File #:	Res 0222-2014	Version:	*	Name:	LU 47 - Zoning, Special Hudson Yards District, Manhattan (N 140191 ZRM)
Type:	Resolution	Status:		In control:	Adopted Committee on Land Use
On agenda:	4/29/2014				
Enactment date:		Enactment #:			
Title:	Resolution approving the decision of the City Planning Commission on Application No. N 140191 ZRM, for an amendment of the Zoning Resolution of the City of New York, concerning Article IX, Chapter 3 (Special Hudson Yards District) in Community District 4, Borough of Manhattan (L.U. No. 47).				
Sponsors:	David G. Greenfield, Mark S. Weprin				
Indexes:					
Attachments:	1. Committee Report, 2. Hearing Transcript - Stated Meeting 4-29-14, 3. Minutes of the Stated Meeting - April 29, 2014

THE COUNCIL OF THE CITY OF NEW YORK RESOLUTION NO. 222

Resolution approving the decision of the City Planning Commission on Application No. N 140191 ZRM, for an amendment of the Zoning Resolution of the City of New York, concerning Article IX, Chapter 3 (Special Hudson Yards District) in Community District 4, Borough of Manhattan (L.U. No. 47).

Map 1 - Subdistrict B: 450 West 33rd Street and Ninth Avenue Rail Yard Public Access Area Plan

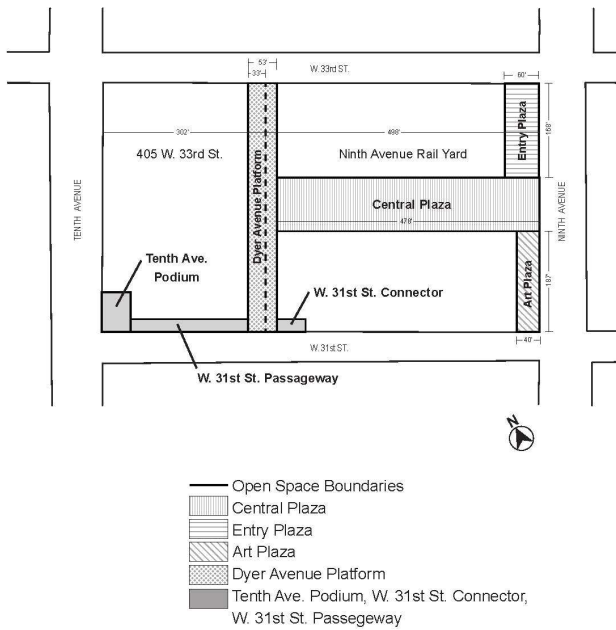
A permanent easement shall be provided along the eastern edge of 450 West 33rd Street, as shown on Map 1 (Subdistrict B: 450 West 33rd Street and Ninth Avenue Rail Yard Public Access Area Plan) in Appendix B of this Chapter, for the purposes of constructing the Dyer Avenue platform required pursuant to paragraph (d) of Section 93-73 (Public Access Areas on Ninth Avenue Rail Yard). Such easement shall have a minimum width of 33 feet. Any amenities required by paragraph (d) of Section 93-73 may be located within such easement.

A publicly accessible area (hereinafter referred to as the "Tenth Avenue podium") shall be provided at the corner of Tenth Avenue and West 31st Street, as shown on Map 1 in Appendix B. The Tenth Avenue podium shall have a minimum area of 1,800 square feet, be located at the
